Access Compliance Report

Public Rights-of-Way

Intersection ID: 10038340	Main Street: SOUTH_BV	Cross Street: N/A	Location: SW
ADA ID: 6DBB1031030A	Ramp Type: Perp	Initial Pass/Fail: Fail	Overall Compliance: No
		Severity Score: 12.5

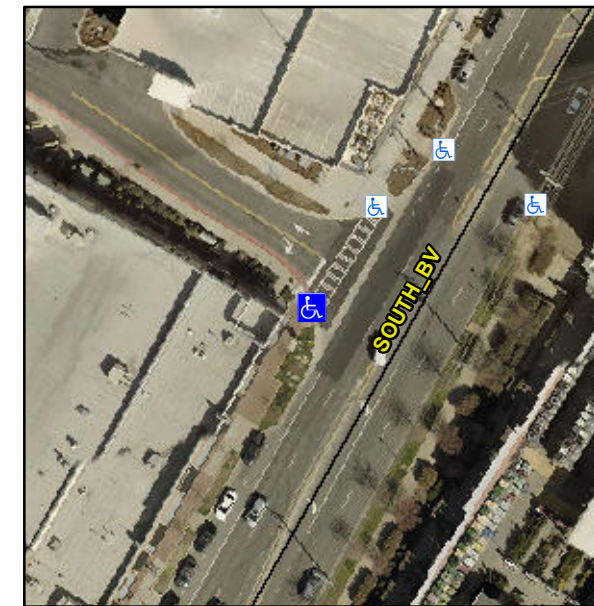
Not Found, R304.2.2

Compliance	Description	Data	Compliance	Description	Data
N/A	Ramp Length (in)	63.0	No	Ramp Slope (%)	11.0
Yes	Ramp Width (in)	48.0	Yes	Ramp XSlope (%)	0.8
N/A	Flare Type LT	N/A	N/A	Flare Type RT	N/A
N/A	Flare Slope LT (%)	N/A	N/A	Flare Slope RT (%)	N/A
N/A	Flare Traversable LT?	N/A	N/A	Flare Traversable RT?	N/A
N/A	Landing Length (in)	N/A	N/A	DWS Provided?	N/A
N/A	Landing Width (in)	N/A	N/A	DWS Contrast?	N/A
N/A	Landing Slope (%)	N/A	N/A	DWS Length (in)	N/A
N/A	Landing X Slope (%)	N/A	N/A	DWS Full Width?	N/A
N/A	Landing Curb? (Y/N)	N/A	N/A	DWS Offset (in)	N/A
N/A	Shared Landing?	N/A			
N/A	Gutter Ponding?	N/A	N/A	Gutter Slope (%)	N/A
N/A	Gutter Lip Ht (in)	N/A	N/A	Gutter X Slope (%)	N/A
N/A	Painted X Walk1?	Yes	N/A	Painted X Walk2?	N/A
	X Walk 1 Direction	To NE		X Walk 2 Direction	N/A
N/A	X Walk 1 Width (in)	113.0	N/A	X Walk 2 Width (in)	N/A
	X Walk 1 Slope (%)	1.8		X Walk 2 Slope (%)	N/A
	X Walk 1 X Slope (%)	1.1		X Walk 2 X Slope (%)	N/A

Remove & Replace Entire Ramp.
